INDESIT company

Model type:
MTAA242HA

Commercial code:
F058561

5172080 Exploded views

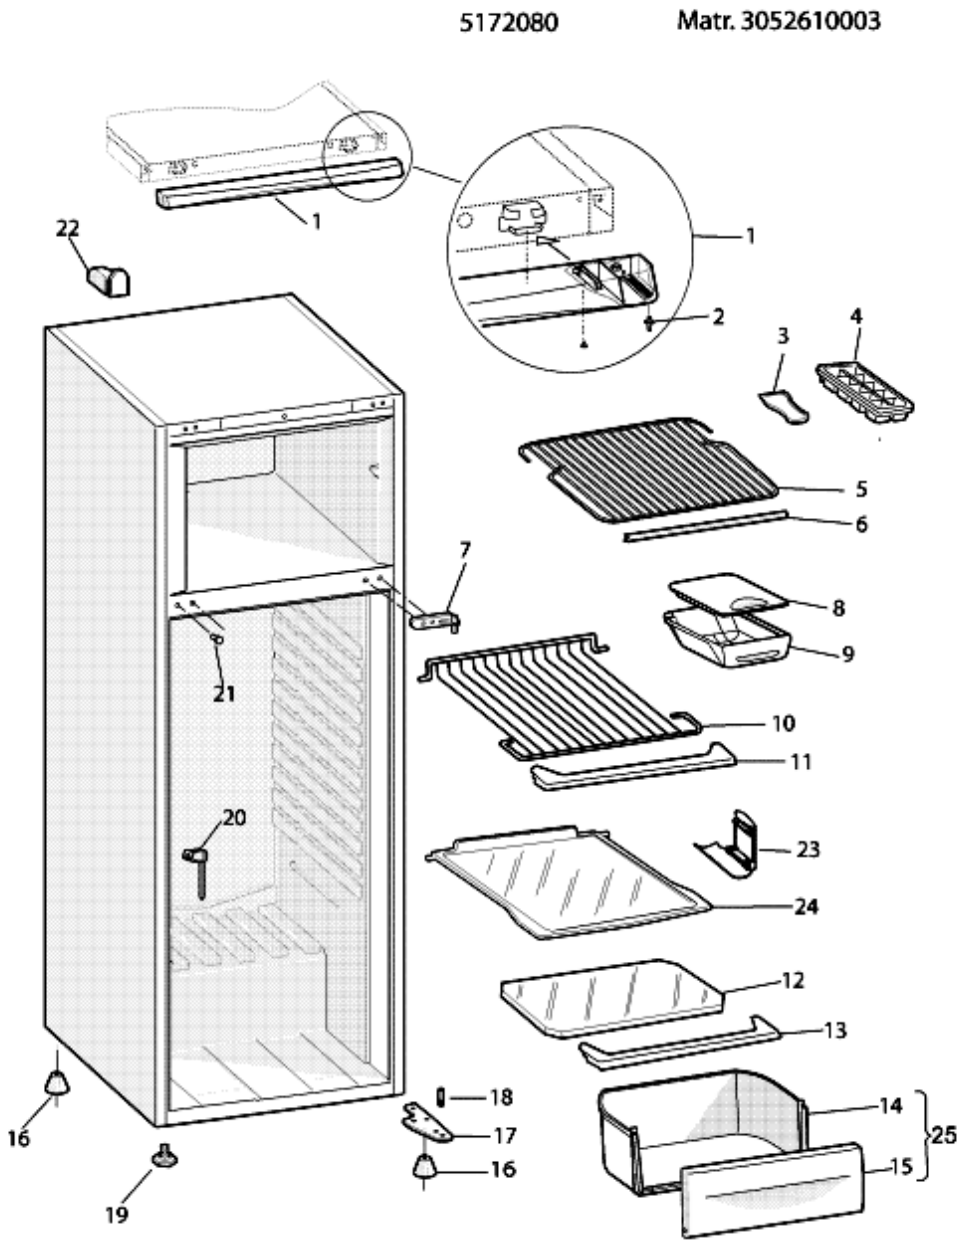
n2513g00: ICE TRAY STANDARDIZATION

Ice tray has been standardized in order to manage only 12cubes version.

5172170 Exploded views

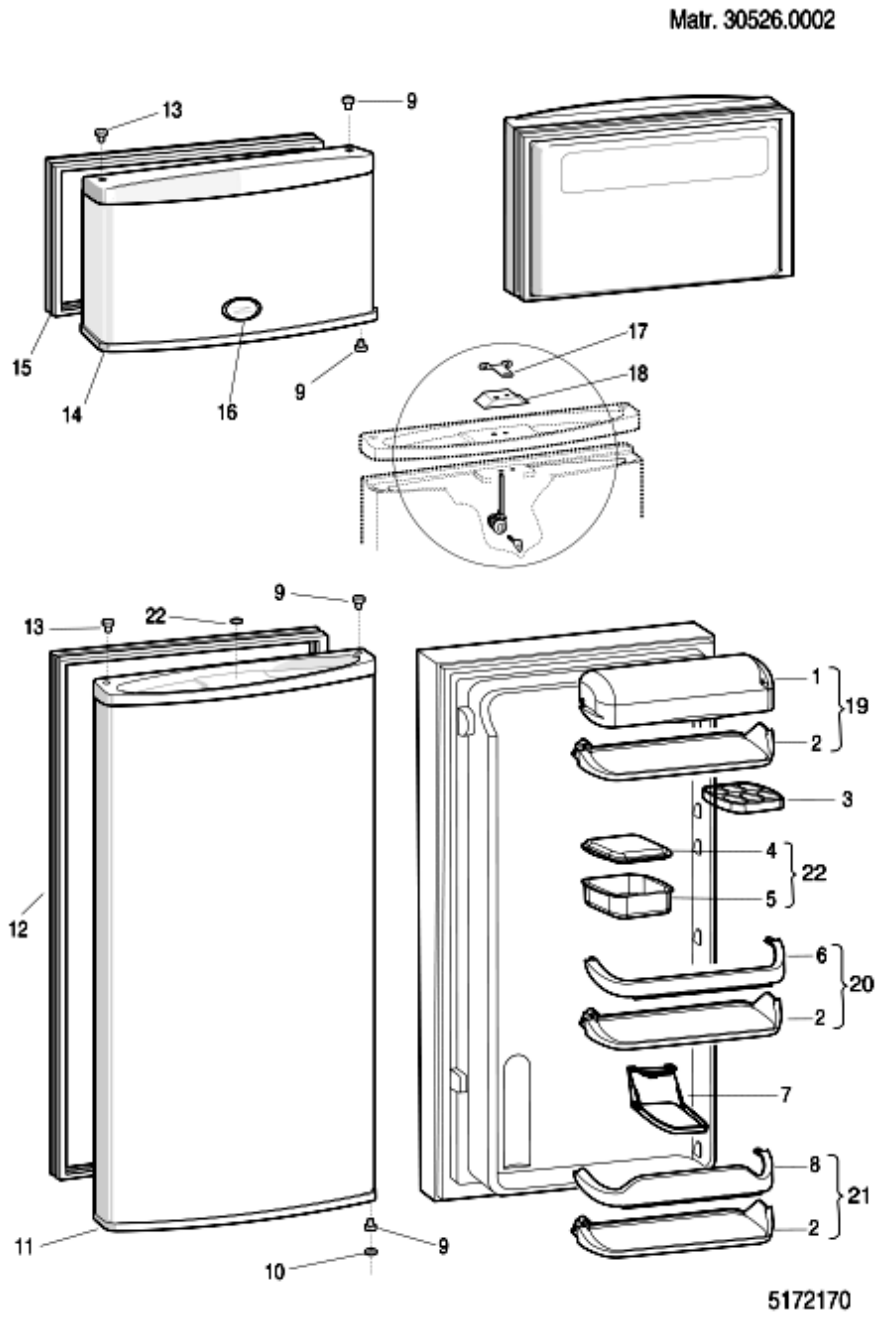
n3010j01: Colour Change of Internal Accessories

The colour of some of the internal shelves and accessories have changed to transparent. This affects models produced in Carinaro-Manisa. Modification is functionally interchangeable therefore once the colour versions of the parts have depleted they will automatically substitute to its corresponding transparent parts. Some parts will have been made obsolete with no substitution.

Some parts have changed from Satin Finish to Shiny (Crystal) Finish. These parts include;
-Door Shelves
-Crisper Front Panels

-Freezer Drawer Front Panels
All pre-modification components will be managed till the end of stock and after they will be substituted with new version.

5212250 Exploded views

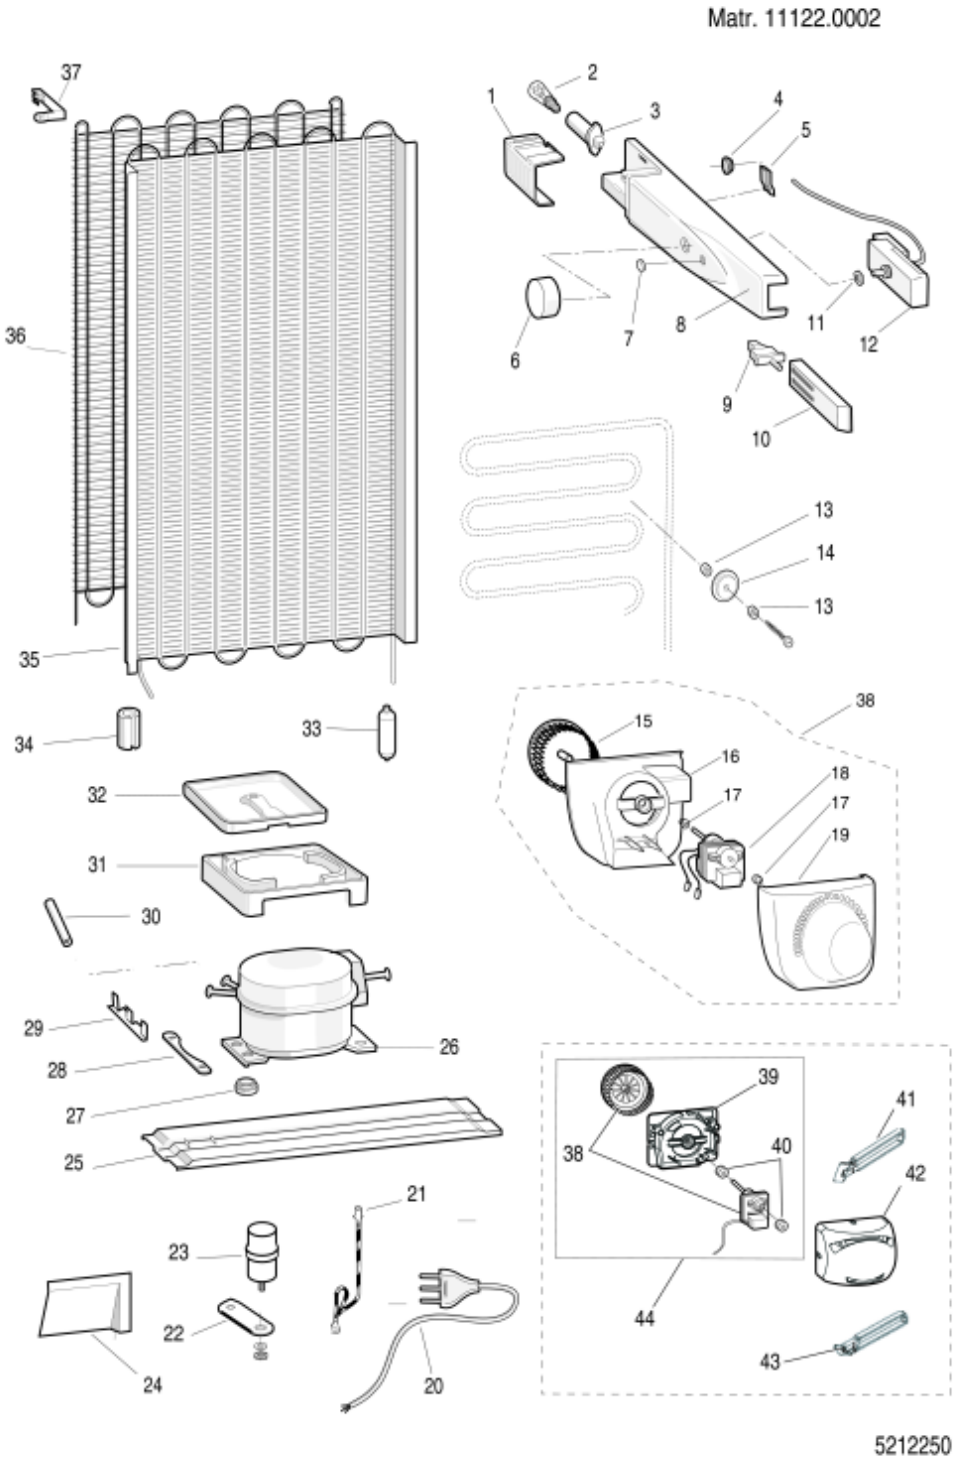
n1025065: Giugiaro-Vossloh thermostat box kit (low Ambient Temp. +16?C)

As of February-2001 (serial no. 10201.0001), the "thermostat box KIT for low ambient temperatures" is being handled with part number 076283 and is to be used on Indesit brand double-door refrigerators that have the Giugiaro thermostat box fitted on them

(048503 - 066297).
The kit should be used exclusively to solve those problems obtained due to the poor performance of the freezer due to an ambient temperature below +16°C.
The kit is innovative, as it has a 6.6 Watt resistance fitted inside the thermostat box that should be activated by the toggle switch with a rubber protection situated underneath the thermostat knob. The switch is activated when the ambient temperature drops below +13°C (contacts closed. See the wiring diagram included in the kit).
This resistance heats up and enables the thermostat to be reactivated, thereby allowing the appliance to operate correctly.
On the thermostat box, the resistance is glued onto an aluminium plate (152x42) itself glued to the box.
When replacing the thermostat box, no components should be re-used, and this includes the wiring.
The wiring in the kit has terminals with fastons for connecting them to the compressor's terminal board; in the event of different solutions, then make the suitable adjustments as necessary.

Moreover, the thermostat box in the kit was obtained from the Giugiaro one (066229) with the Vossloh lamp holder and the Eltek switch. On this box, the position of the fixing hole was moved 15 mm up; therefore, on the models that are fitted with the Giugiaro thermostat box (048503), the hole on the cabinet should be remade before mounting the kit.
Moreover, on the models that use the hidden bulb thermostats, the position of the mark should be remade on the thermostat in the kit and, if necessary, the sheath protecting the bulb should be removed.

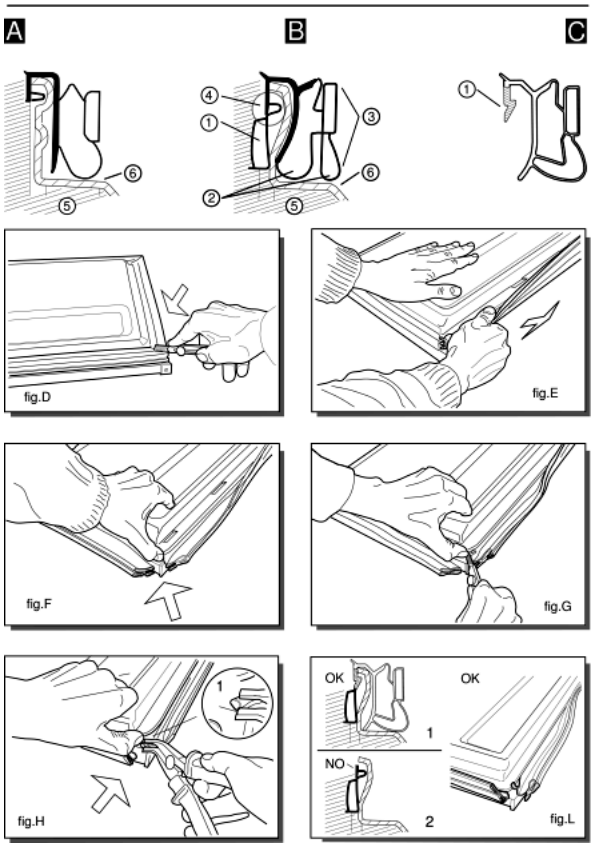
0521123: SEALS FOR DOORS FOAMED AS ONE PIECE

Various types of gaskets with different profile, as shown in figures (A) and (B), are used to fix the door (fig. A-5; B-5) and the inner door (fig. A-6; B-6) on the block foamed doors of combined freezers and refrigerators.
---Ilpea profile 245; 179; 412 (fig.A)
---Ilpea profile 287 (fig.B)
When replacing gaskets with profiles 245; 179; 412 these are fixed with screws (2 per corner) to the door.
Gaskets with profile 287 can not be used as spare parts but are designed to house the Ilpea type 900 gaskets (see figure C).
When replacing the gasket (287), once it is removed you will find a pocket (fig. B-1) between the door and inner door.
The rigid tooth (fig.C-1) of the gasket (900) is inserted inside between the pocket and the inner door, doing away with the need for screws.
Gasket with profile 287 is easy to identify since it has an exterior double edge (fig.B-2) which acts as a cushion when the door is closed.

To replace this gasket, follow these steps:
---Dismount the door and cut the four corners of the gasket along the joint (fig.D);
---lift the gasket and pull it carefully along its full length without tearing it (fig.E).
The purpose here is to detach the inner door slightly from the foam along the exterior edge for a depth equal to that of the gasket (fig.B-3);
---lift the corner of the inner door slightly, prising it up with your thumb (fig.F). Do not use a tool which might break the inner door;
---continue cutting the gasket inside the inner door for about 6 mm (fig.G);
---push in the tip of the pliers (type USAG N131) and pull outwards until you see the top edge of the pocket (fig. B-4) which is empty (fig.H-1);
---if you carry out this operation correctly (fig.L) you will be able to pull off the top edge of the pocket for the full length of the door.
If the gasket tears before the top edge (fig. L-2) you should repeat this operation from the other corner of the door.
